# **Proposed Timaru District Plan**

# Section 42A Report: Subdivision and Development Areas

**Report on submissions and further submissions**

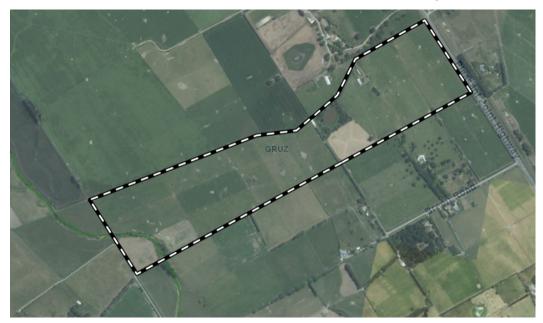
7.6.10 An esplanade already exists on the south side of the Hae Hae Te Moana River as shown in the Figure below. The presence of the existing esplanade is also a matter for consideration at the time of any future subdivision; and in particular whether the opportunity would be taken to take any additional esplanade on the north side of Hae Hae Te Moana River. I note there are other instances where esplanades have already been taken along waterbodies listed in **SCHED12**, in those cases the line still appears on the planning maps. In my view this is appropriate as one of the key matters for the provision for esplanades is continuity along the length of the waterbody. On that basis I recommend that the submission from Wallwork, C [2.2] be rejected.

- 7.6.11 The property at 403 Pleasant Point Highway is shown on the Figure below. Papaka Stream cuts across the SW corner of the property. In my view farm access to this small area of land is a matter that would form part of any future esplanade provision at the time of future subdivision. In that case it might be that an esplanade strip with an easement for access is appropriate in order to ensure that access is maintained and the balance land is continued to be farmed in accordance with the underlying zone purpose.
- 7.6.12 In my view whether an area is subject to flooding is largely irrelevant to whether an esplanade is taken. By their very nature, the riparian areas making up esplanade reserves/strips are inundated during flood events. I recommend that Papaka Stream is retained in **SCHED12** and that the submission from Hart, JR [149.4] is rejected.

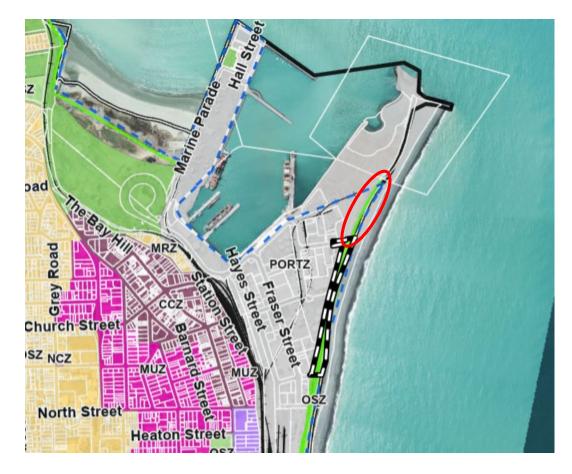
- 7.6.14 SCHED12 notes that the entire length of Ōrakipaoa Creek is subject to esplanade provision, but particularly notes the area from the coast to Milford Lagoon Road. No other landowners adjoining Ōrakipaoa Creek are seeking the esplanade provision be removed. I recommend that the esplanade provision on Ōrakipaoa Creek remain in SCHED12 and that the submission from Connelly, S [136.3] is rejected.
